TITLE OF AGENDA ITEM: A RESOLUTION OF THE TOWN OF DAVIE, FLORIDA, AUTHORIZING THE MAYOR TO EXECUTE CHANGE ORDER NUMBER 2 BETWEEN THE TOWN AND WHARTON-SMITH, INC. FOR WATER PLANT IMPROVEMENTS AND WATER TRANSMISSION MAIN.

Re: WTP Improvements & Water Transmission Main
B-02-74
Change Order Number 2
CG&A Project No. 99-1165.3

CHANGE ORDER

PROJECT: Water Treatment Plant Improvements &
Water Transmission Main**OWNER:** Town of Davie**CONTRACTOR:** Wharton-Smith, Inc.**OWNER'S PROJECT NO.:** B-02-74**CONTRACT FOR:** Town of Davie Utilities Dept.**ENGINEER:** Calvin, Giordano & Associates Inc.**ENGINEER'S PROJECT NO.** 99-1165.3

SK-1

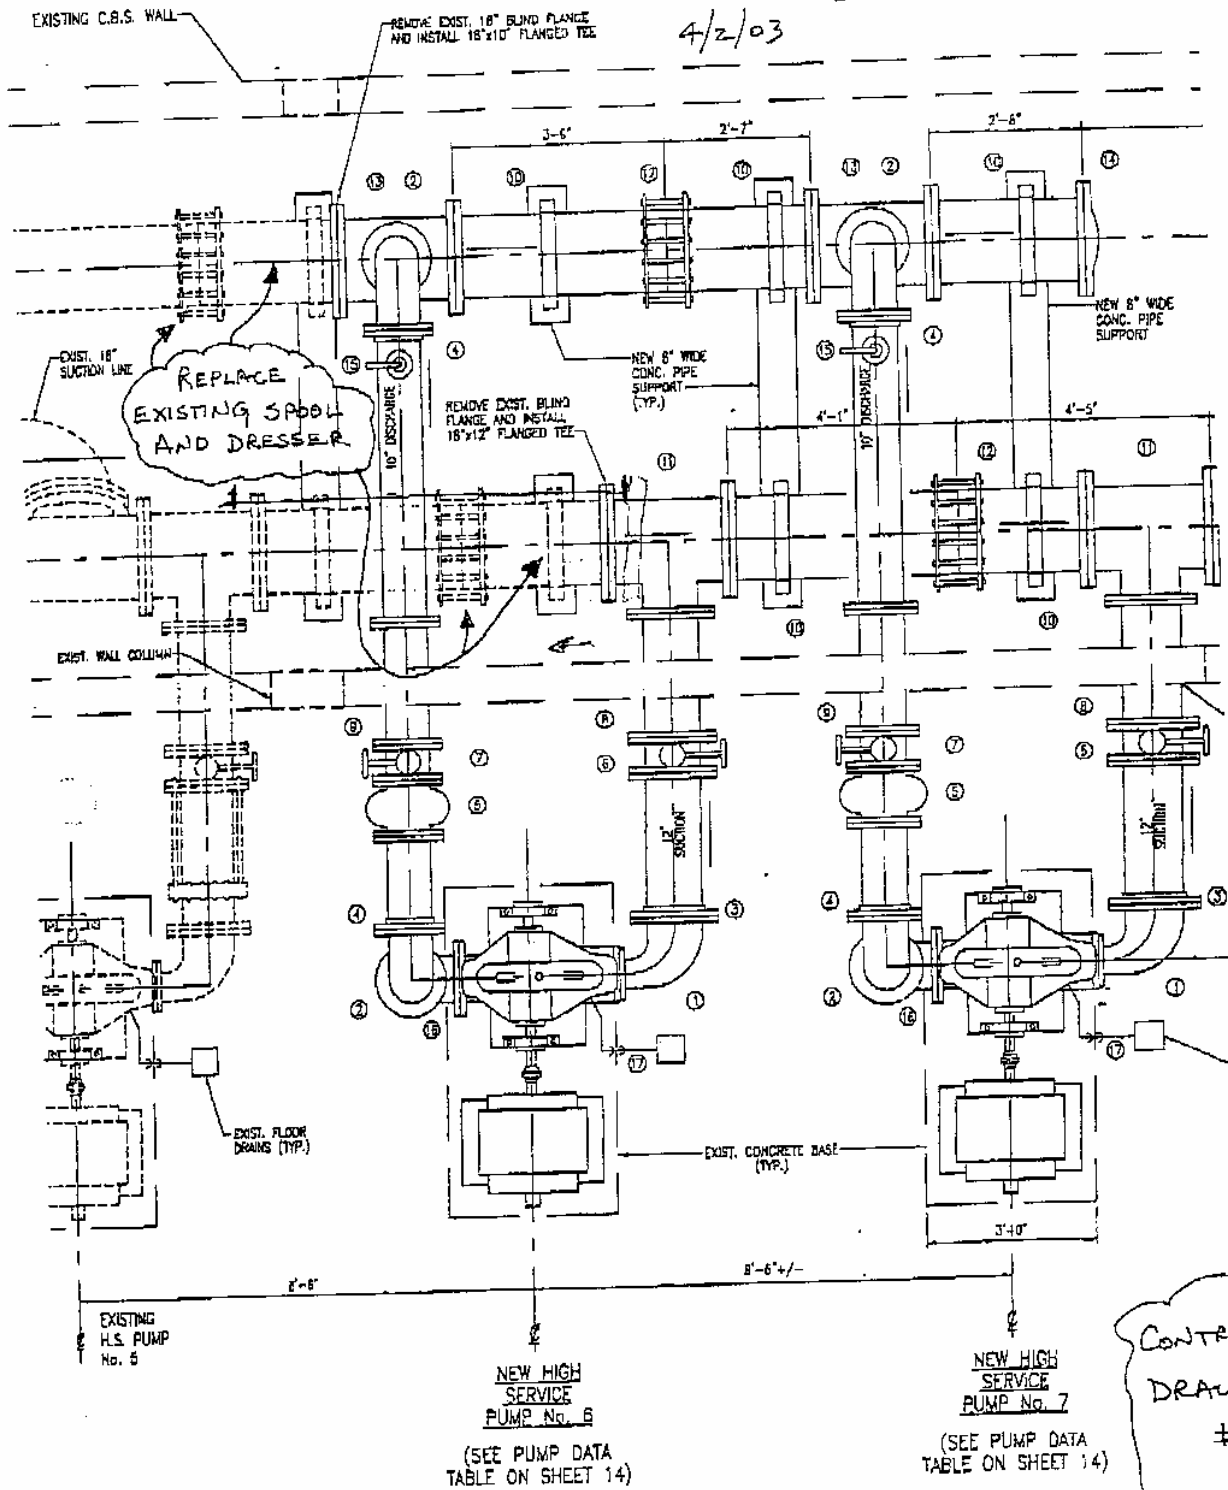
During the final layout of the new 18" high service pump station discharge and suction piping on March 31, 2003, Wharton-Smith discovered that the existing flanges on both the 18" suction and discharge header piping are approximately 5" shorter than what is shown on Contract Drawing 12. As a result, if the new 18" suction and discharge tees are placed on the existing flanges as shown on the drawings, the new pumps will shift approximately 5" to the West, and will not fit on the existing pump pads.

Wharton-Smith recommends that new, longer, 18" flange x pe suction and discharge spools be purchased to replace the existing 18" flange x pe suction and discharge spools to the existing dresser couplings. (See attached sketch, SK-1) Since the existing 18" dresser couplings on the suction and discharge header piping appear to be damaged, Wharton-Smith also recommends replacing the existing dresser couplings.

- 4) Remove the existing flanged pipe and pipe couplings in the high service pump gallery and replace with new flanged pipe and couplings for a cost of \$5,245.

- 4) During the installation of the high service pumps it was discovered that the existing flanged pipe was too short to make the connection to the proposed piping and the existing couplings were found to be deteriorating. In order to utilize the existing pump support pads and conduits the existing flanged piping and couplings were replaced with longer pipe and new couplings.
